1ST FLOOR SPRINKLER PLAN  
SCALE: 1/8" = 1'-0"

**GRAND LAGOON CONDOS** 2461 NORTH  
1141-1163 MARINA DRIVE SLIDELL, LA  
SPRINKLER PLAN

**JEFFERSON SPRINKLER, INC.**  
"Fire Protection Specialist"

3RD FLOOR SPRINKLER PLAN  
SCALE: 1/8" = 1'-0"

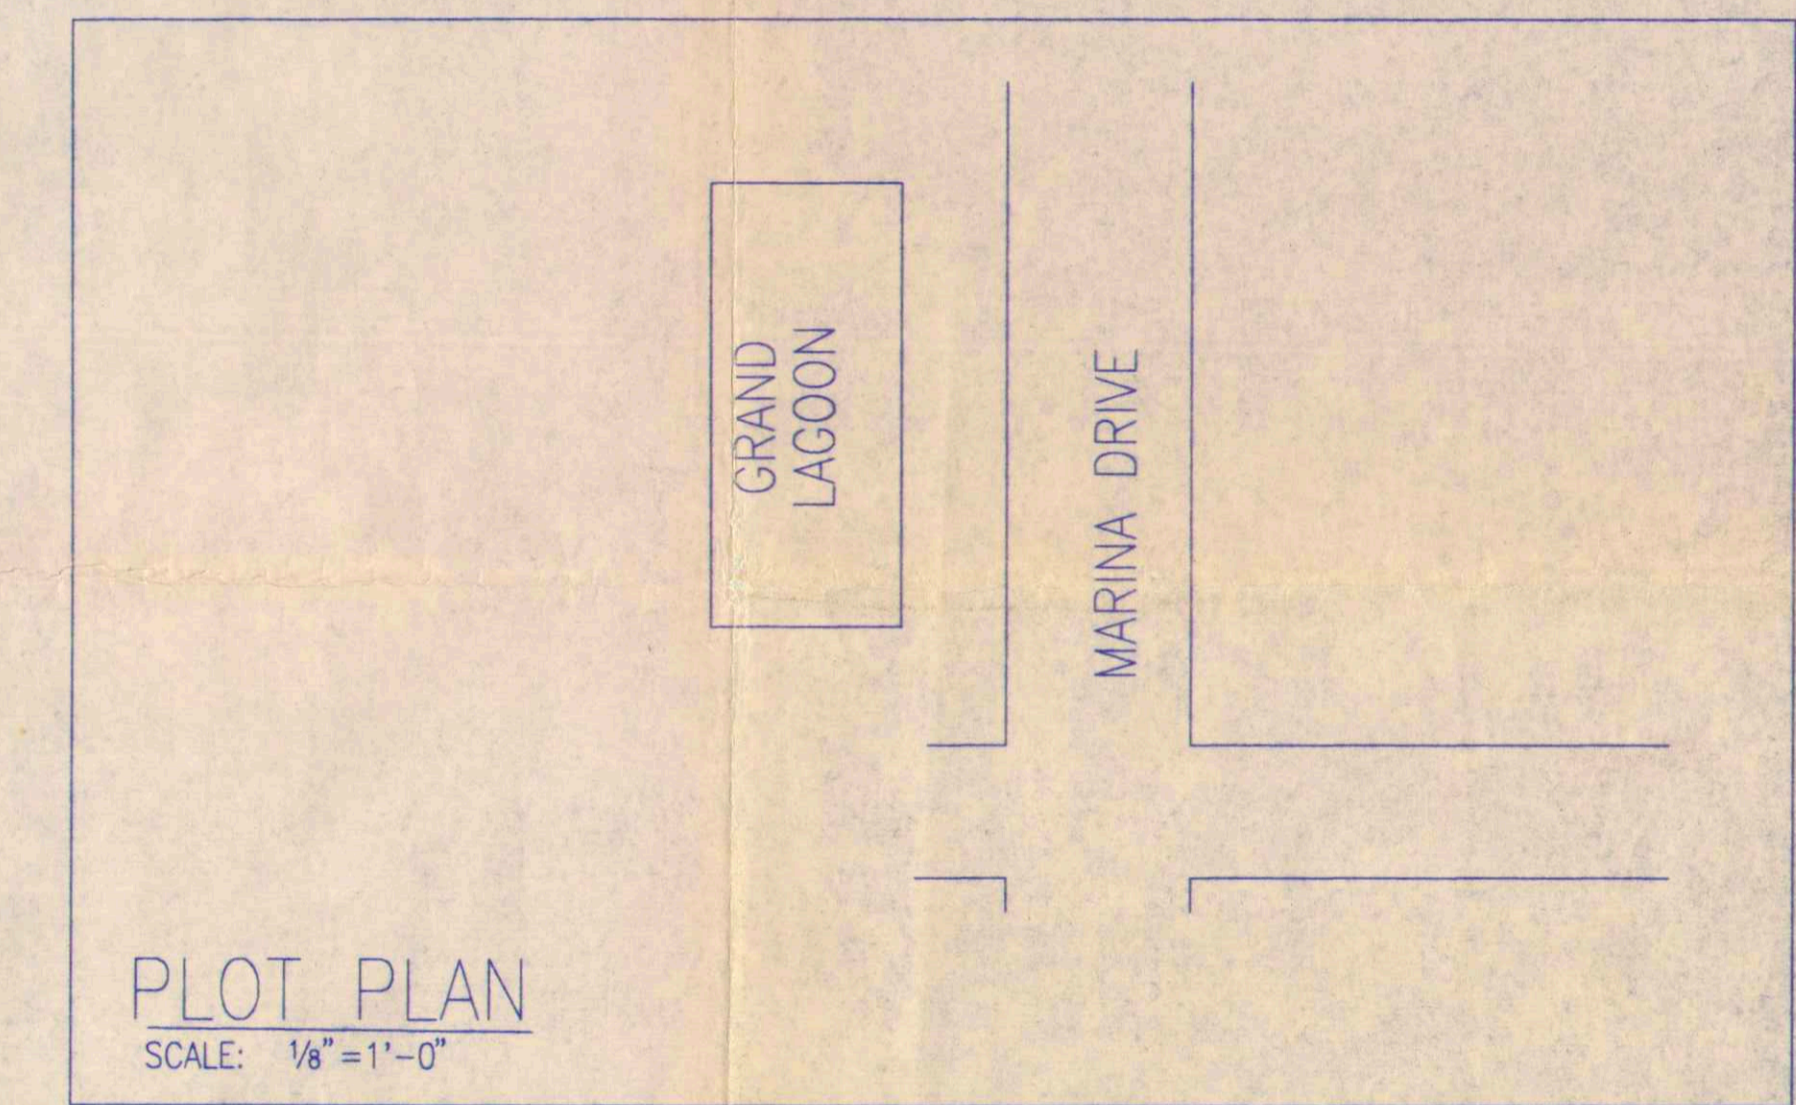
Notice: Pipe to installation vendor to coordinate installation, as activities w/ Architect Management Co. 8/28/01
